# CITY PLAN COMMISSION STAFF REPORT

**I-49 Commerce Center**

- .1 - CD-CPC-2022-00019 – Rezoning Without Plan.
- .2 - CD-CPC-2022-00025 - Development Plan.

Case Number: CD-CPC-2022-00025

PRELIMINARY STREAM BUFFER PLAN (OVERALL)

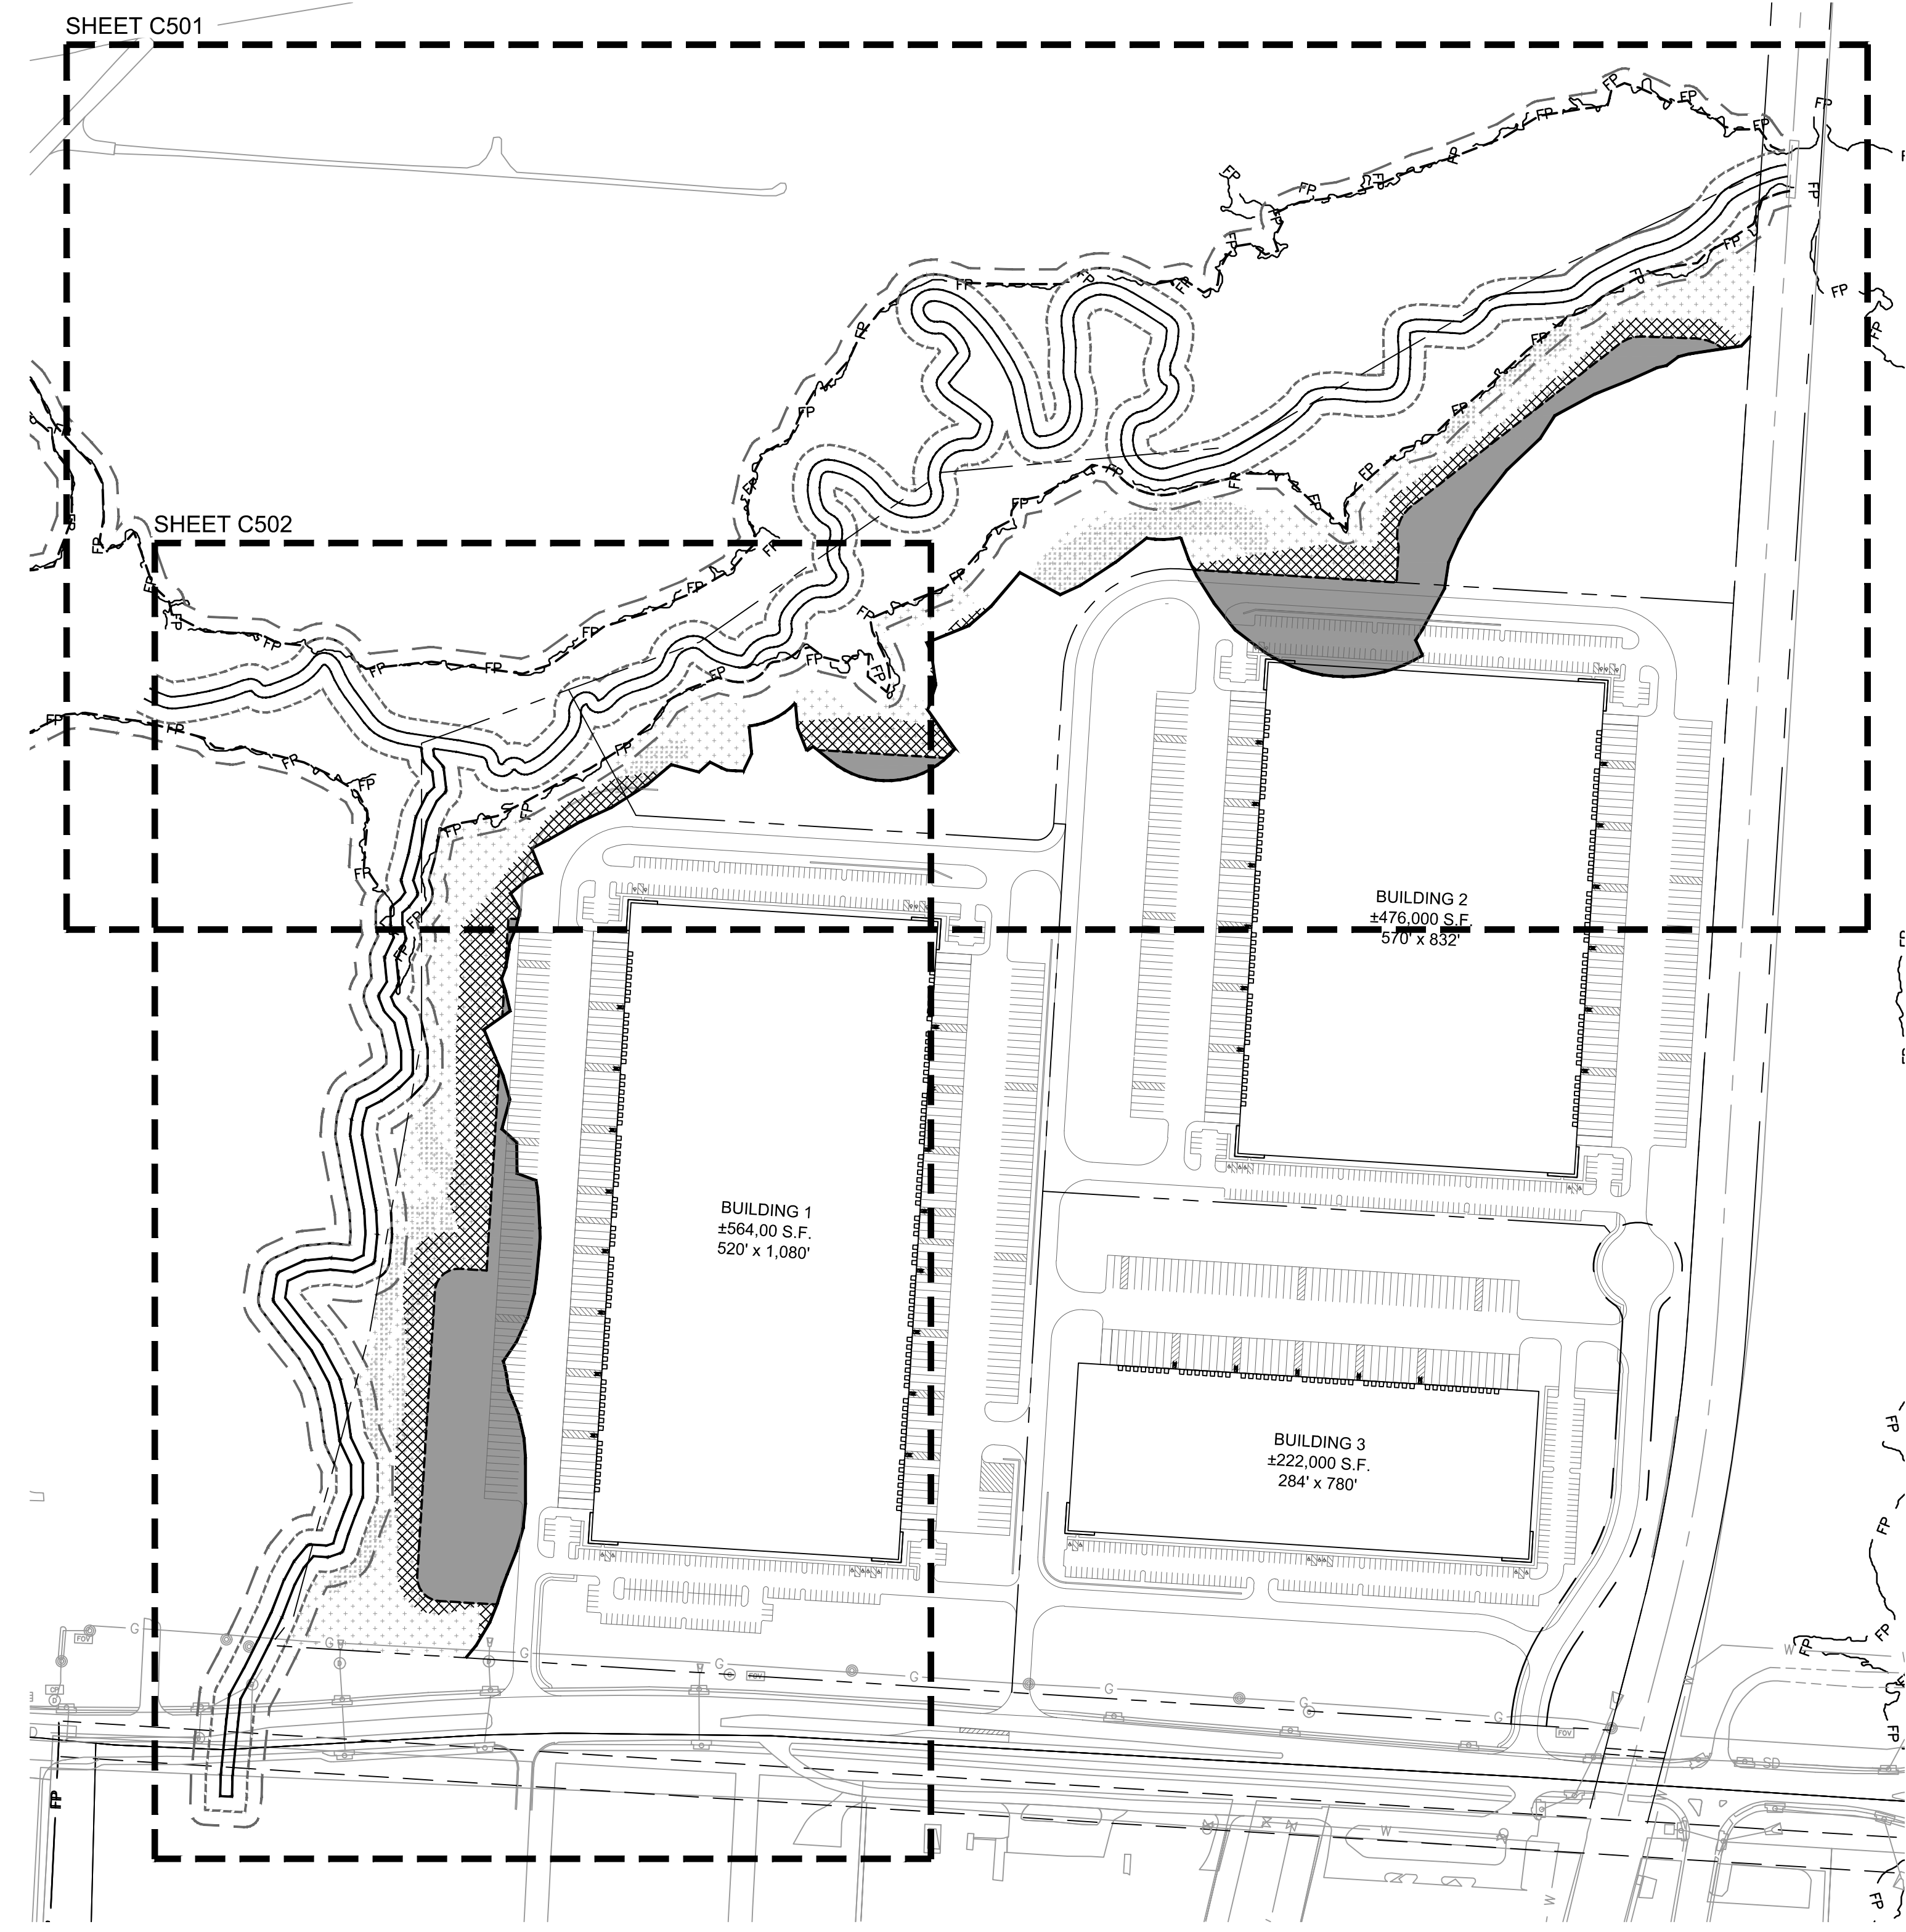
6. The developer shall submit a Preliminary Stream Buffer plan prior to approval of the plan in accordance with the Section 88-415 requirements.
7. The developer shall cause the area to be platted and processed in accordance with Chapter 88, Code of Ordinances of the City of Kansas City, Missouri, as amended, commonly known as the Development Regulations.

15. The developer shall submit a final stream buffer plan to the Land Development Division for approval prior to issuance of any building permits and obtain permits for the Stream Buffer prior to removal of any mature riparian species within the buffer zones due to construction activities on the site, in accordance with the Section 88-415 requirements.

LANDSCAPE PLAN (OVERALL)

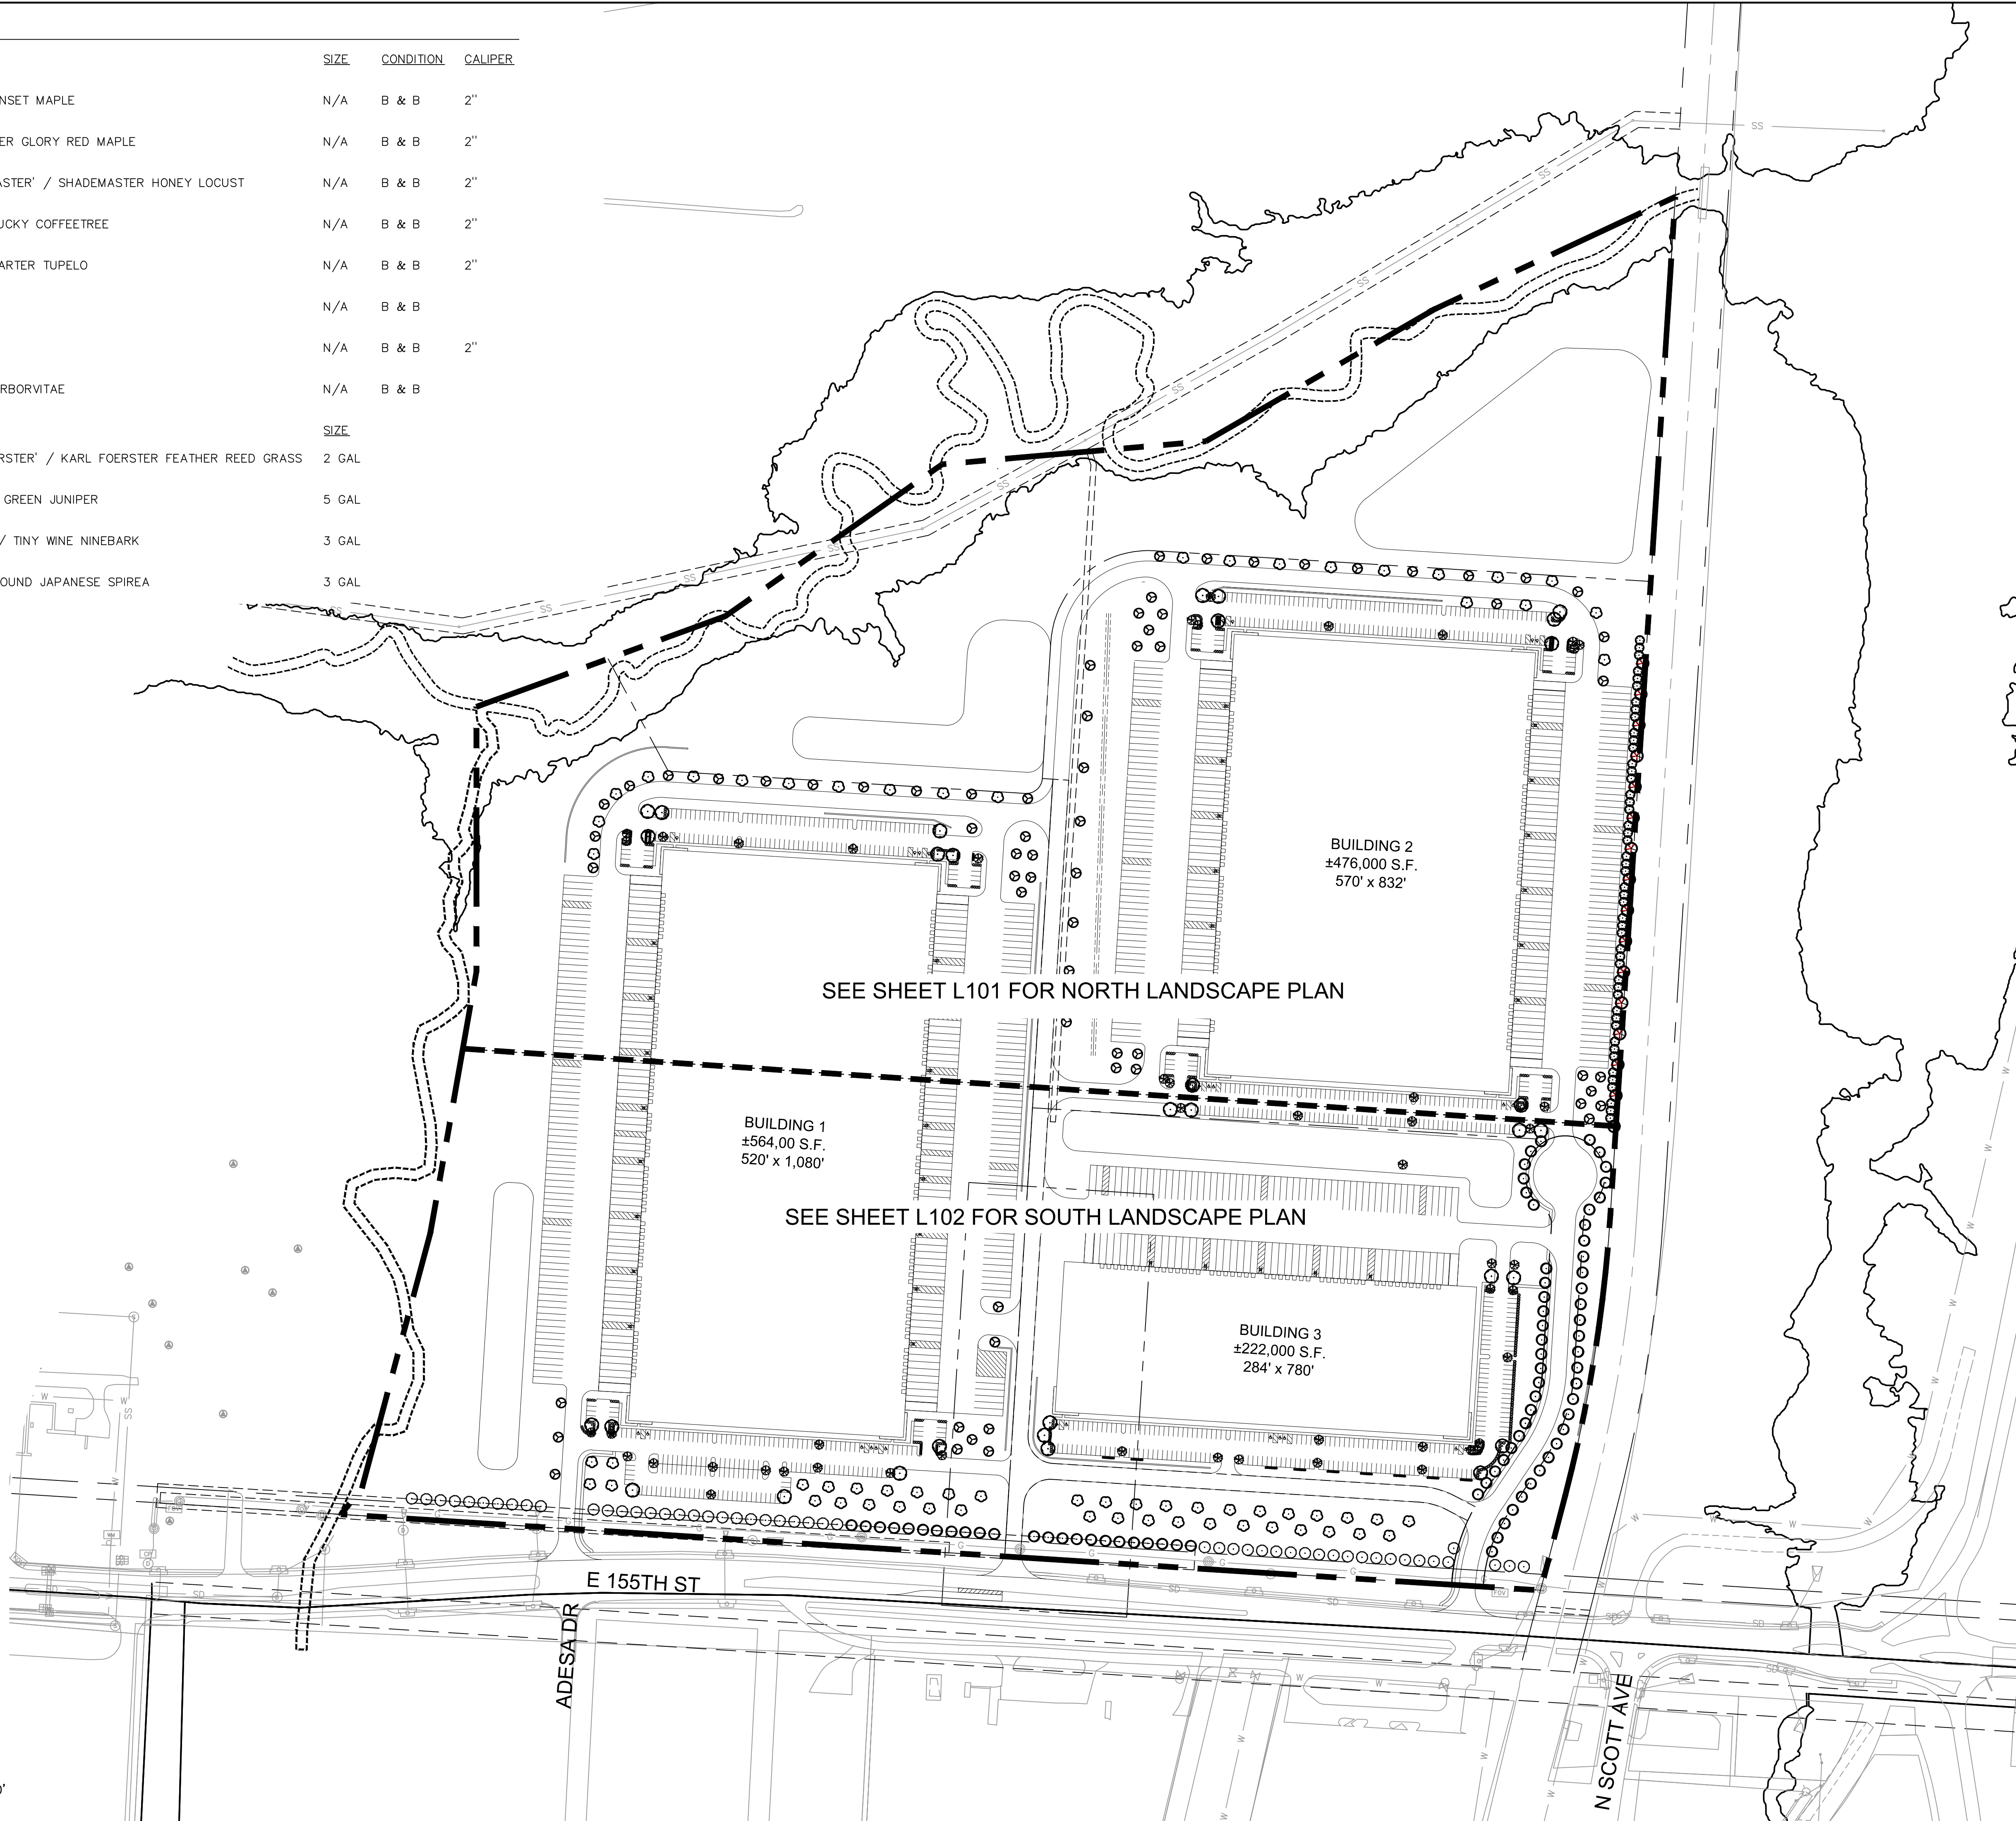
*The applicant has provided a landscaping plan that focuses landscaping elements along the public roadway frontages per staff recommendation.*

4. That all signage shall conform to 88-445 and shall require a sign permit prior to installation.
5. That alternative compliance landscape standards are hereby approved subject to the plan being revised to a dense and continuous row of evergreen shrubs along the south side of all parking lots visible from 155th St.
